ADDENDUM NO. 01

Pentwater Public Schools – Boiler Replacement
600 E. Park Street
Pentwater, MI 49449

Addendum #1

Project No.:	24-0301	Date:	April 23, 2025
Project:	Pentwater Public Schools 2024 Bond Implementation – Bid Package 1	A/E Firm:	C2AE
		Project Manager:	Steve Jurczuk
Owner:	Pentwater Public Schools 600 East Park Street Pentwater, MI 49449

1M-100

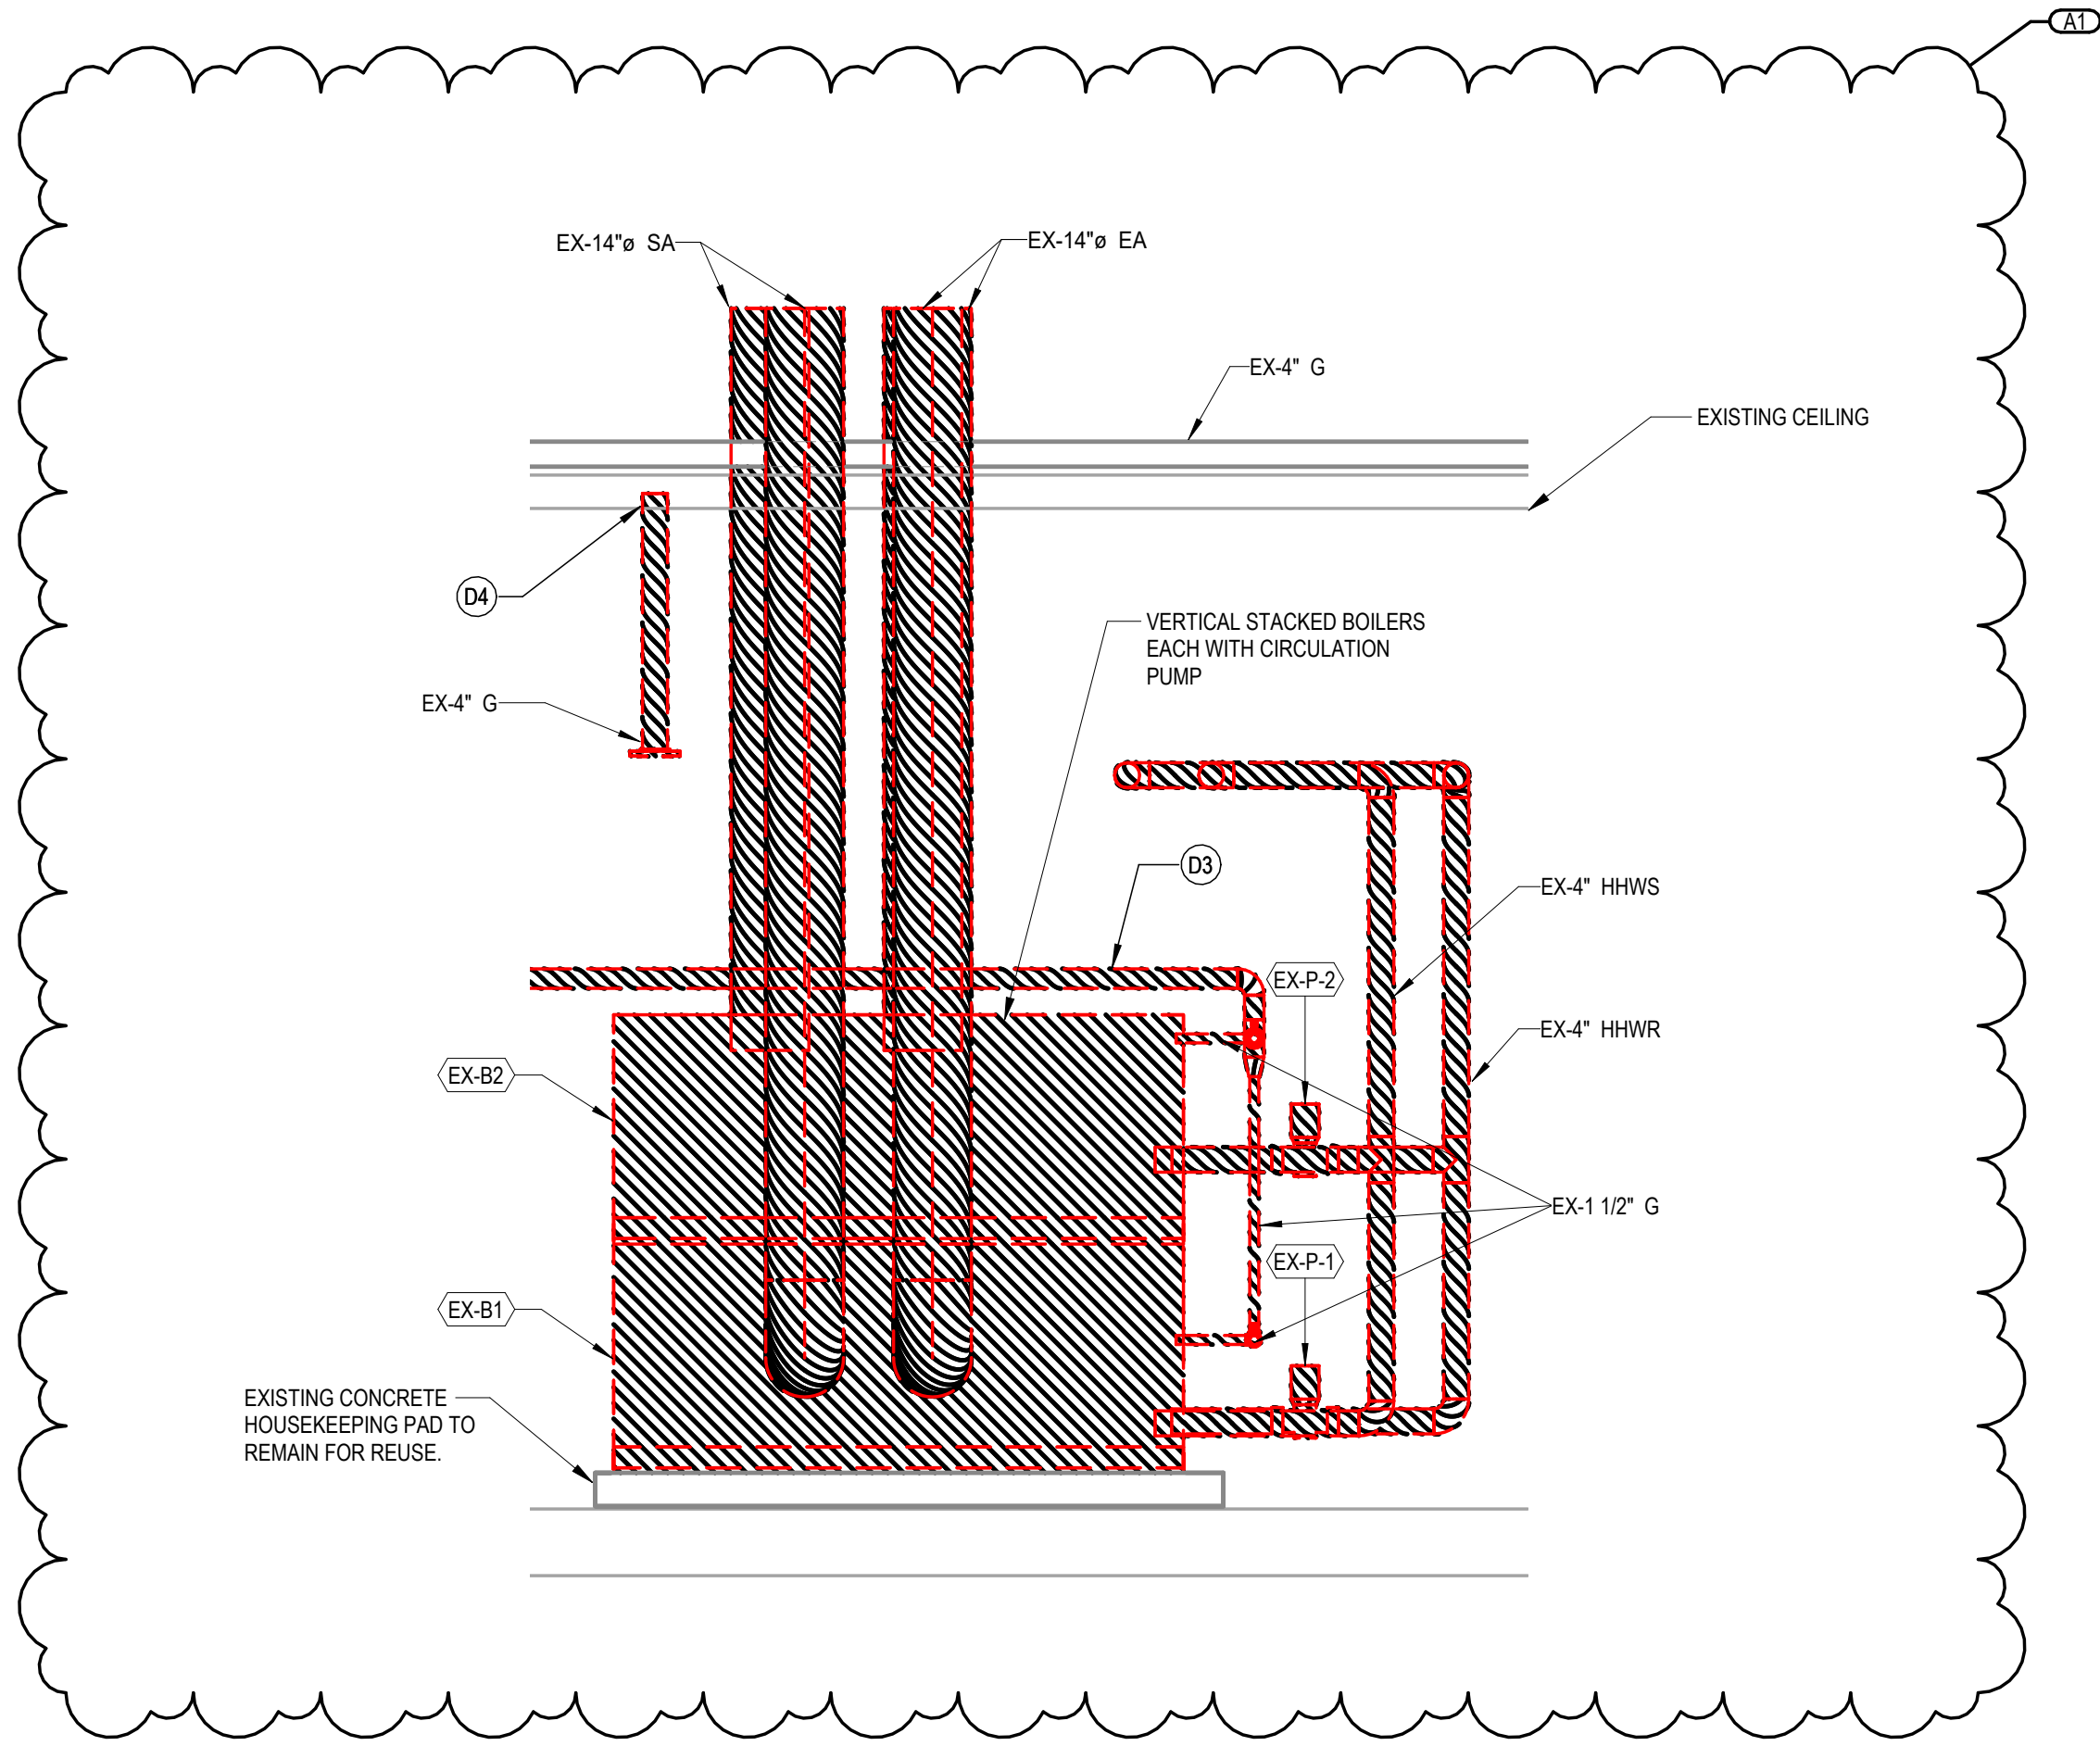
A1.8 Refer to Sheet 1M-100 (reissued):

- a. Mechanical Keynote M5 revised to communicate correct doorway size.
- b. Keynote and abbreviation tables shifted to avoid overlap.

CL1	<p>NEUTRALIZATION KITS TO FLOOR DRAIN.</p> <p>MS</p> <p>CONSENTED WITH THE PROJECT. SEE REF. TO IN-50 FOR DETAILED VIEW. REF. TO ARCHITECTURAL SHEET FOR ROOF SCOPE.</p> <p>MS</p> <p>FIELD VERIFY REQUIRED CLEARANCE FOR NEW BOLLER. EXIST DOOR APPROX 35" CLEAR. DOOR OPENING APPROXIMATELY 35" CLEAR WITH JAMB REMOVED. FIELD VERIFY DIMENSIONS.</p>
-----	---

MECHANICAL DEMOLITION PLAN - BOILER ROOM
1/4" = 1'-0"

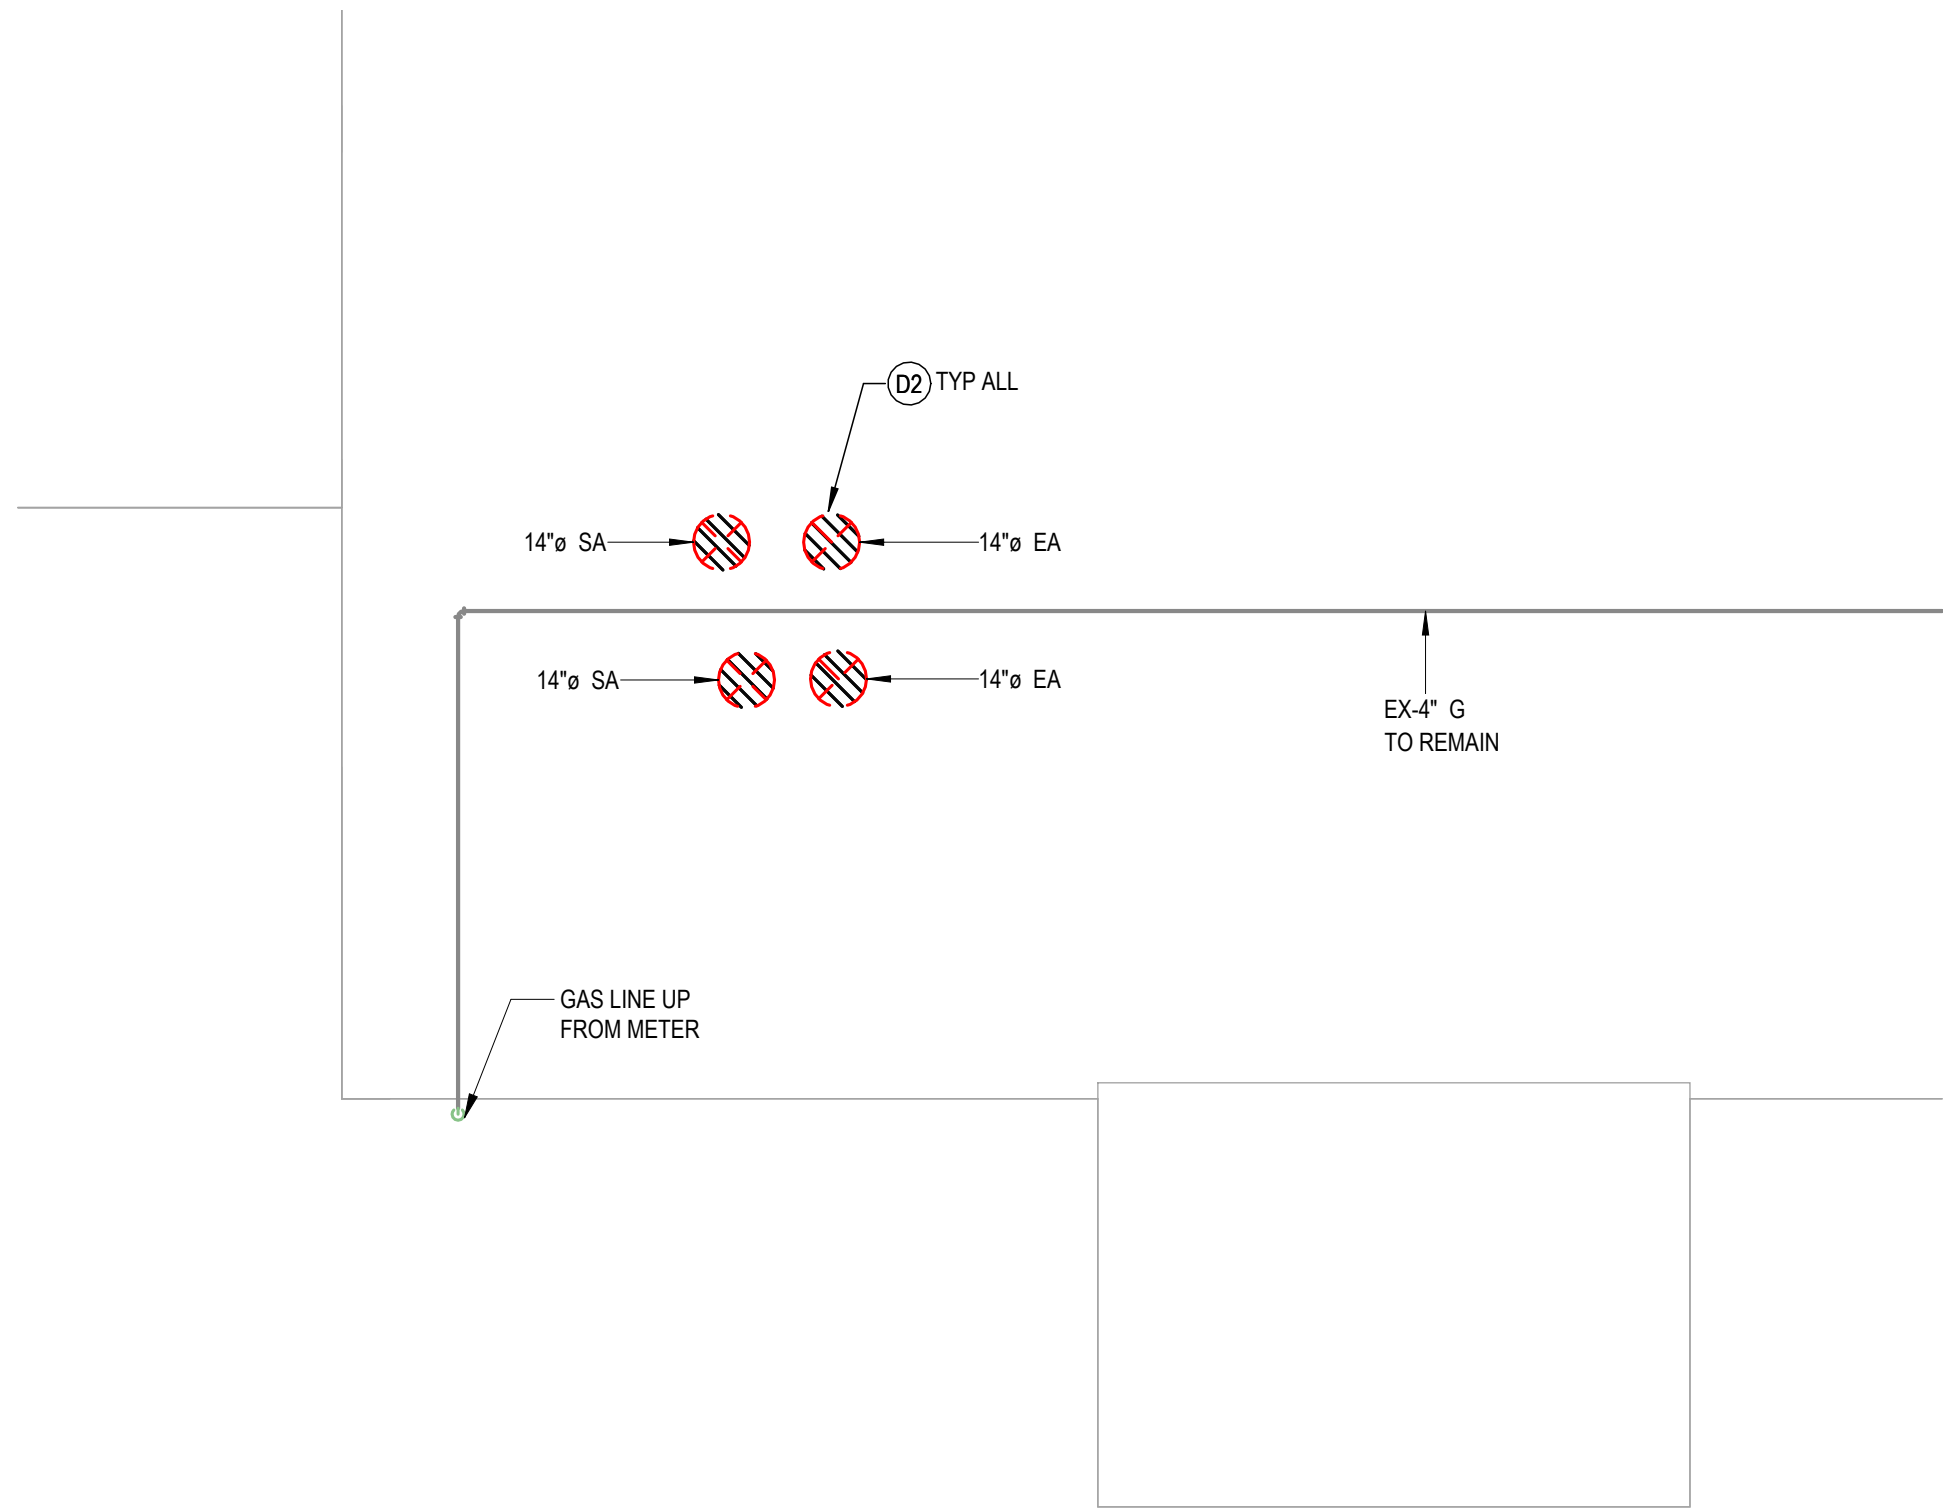
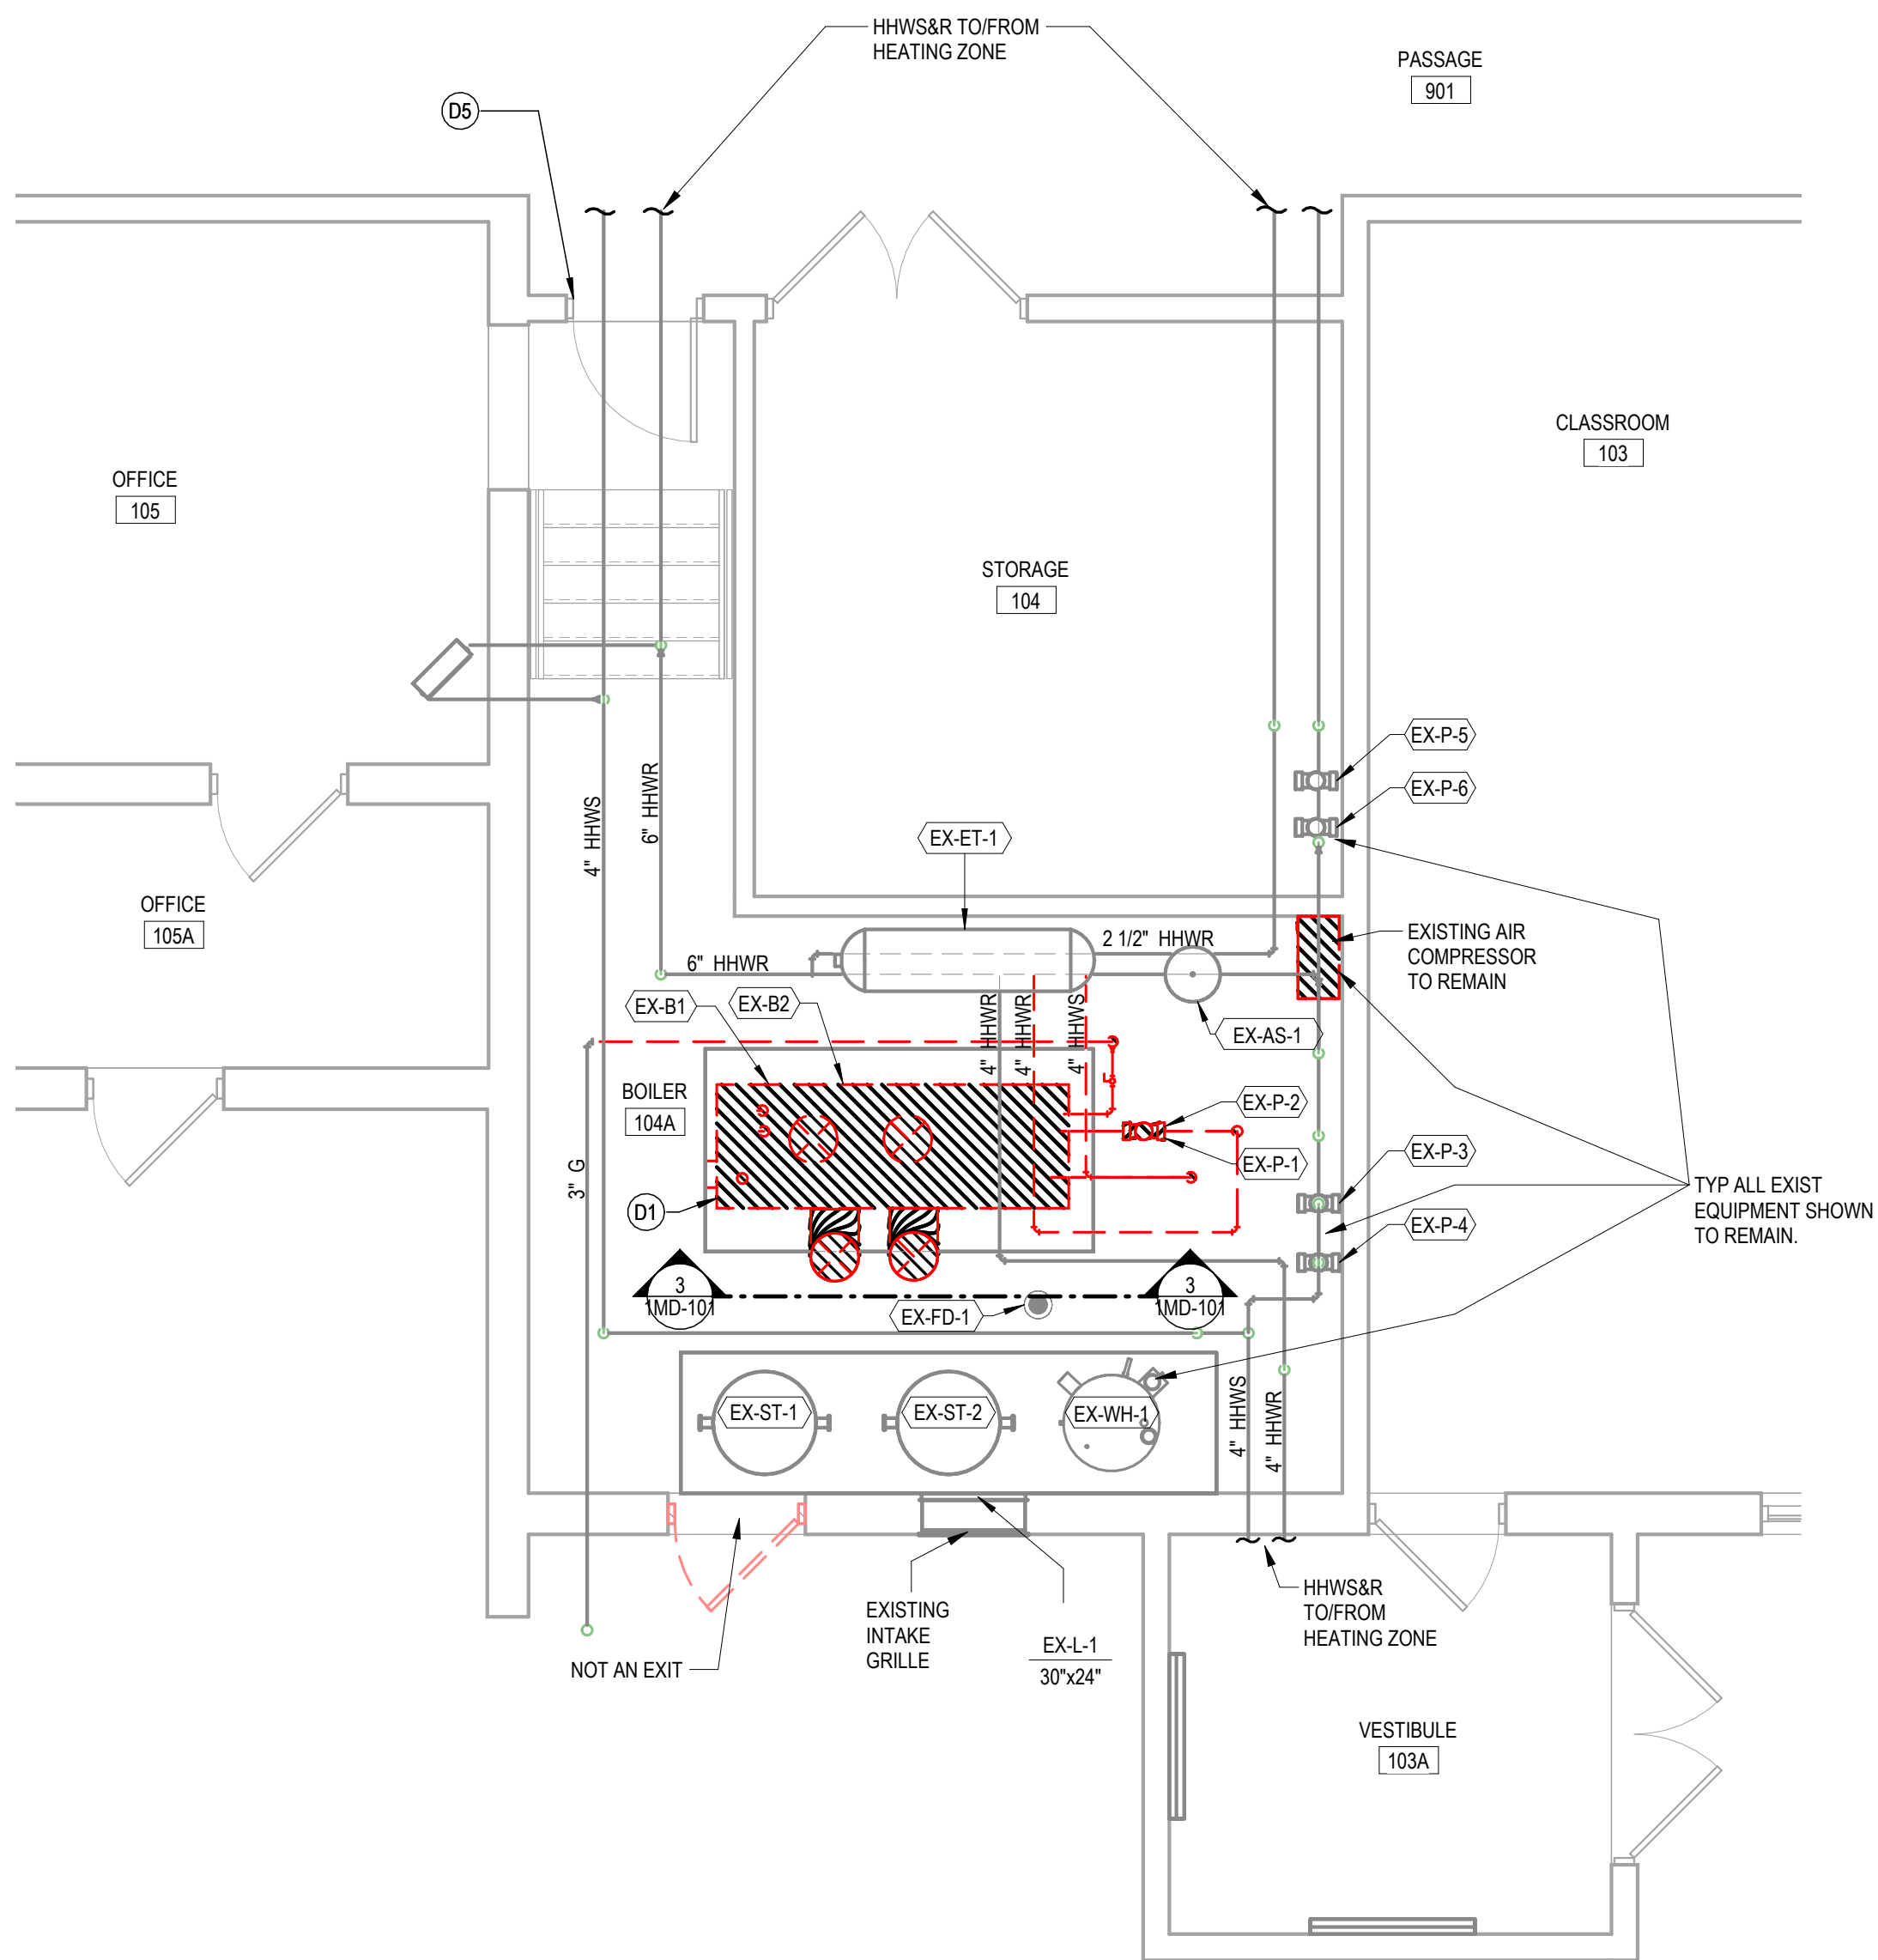
A1.7 Refer to Sheet 1MD-101 (reissued):

- a. Boiler demolition section edited for clarity
- b. Mechanical demolition keynote D5 revised to communicate correct doorway size.

MECHANICAL DEMOLITION KEYNOTES	
KEY VALUE	KEYNOTE TEXT
D1	DEMOLISH EXISTING BOILERS, INDICATED PIPING, SUPPORTS, AND ANCILLARIES ENTIRELY. CAPPING MAIN AND PREPARE FOR EXTENSION TO NEW BOILERS. EXTEND EXISTING HOUSEKEEPING PAD AS INDICATED ON MECHANICAL PLAN.
D2	DEMOLISH EXISTING BOILER FLUE AND VENT THROUGH THE CEILING AND ROOF. REFER TO ARCHITECTURAL SHEET FOR CEILING AND ROOF SCOPE.
D3	DEMOLISH NATURAL GAS LINES AND SHUTOFFS CONNECTED TO BOILERS. DEMOLISH GAS LINE TO ELBOW OR AS FAR BACK AS NEEDED FOR FUTURE WORK.
D4	DEMOLISH AND CAP FORMER GAS LINE AT CEILING LEVEL.
D5	DISASSEMBLE EXISTING BOILER AS NEEDED FOR REMOVAL THROUGH PASSAGE AND DOORWAY. EXIST DOOR APPROX 34" CLEAR. DOOR OPENING APPROXIMATELY 38" CLEAR WITH JAMB REMOVED. FIELD VERIFY.
